**Deepwater Horizon
Technical Rig Audit
January 2005**

Introduction

At the request of George Coltrin, Drilling Operations Team Leader, NAX deepwater GoM a technical rig audit was undertaken of the Deepwater Horizon semi submersible drilling rig. The Deepwater Horizon will undertake deepwater exploration wells, the initial two NAX exploration wells, Stones and Kaskida, represent significant challenges. The Stones well will be drilled in 9600' of water, representing the deepest water depth the rig has worked in. The Kaskida well will be drilled through 15,000' of salt to a total depth of 33,000' MD, representing a record depth well.

Schematic 1 Screen shot of total power demand whilst running casing, (14 MW available)

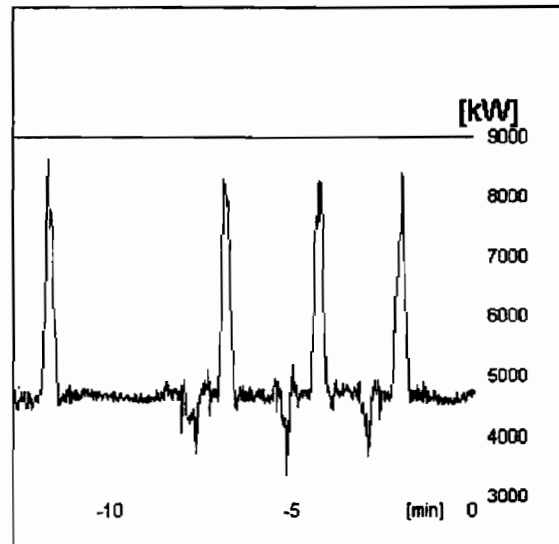
The screens that were displayed at the operator stations were suitable given the current rig work scope. The DP operators were monitoring real time variables and were conversant with the application of trends. Typically when running casing and tripping drill pipe their focus of attention was on available power and also frequency fluctuations. In one instance where casing was being run regenerative braking was causing short-term peak demands and fluctuations and a concurrent frequency drop occurred. As this dropped below 58.5 Hz for more than 2 seconds then a load limit signal is generated that caused the thrusters to phase back by 50%. Once frequency increased to acceptable limits the load limiting is disengaged and normal thruster load restored. This occurred whilst onboard but demonstrates that the DP awareness with operational experience is increasing.
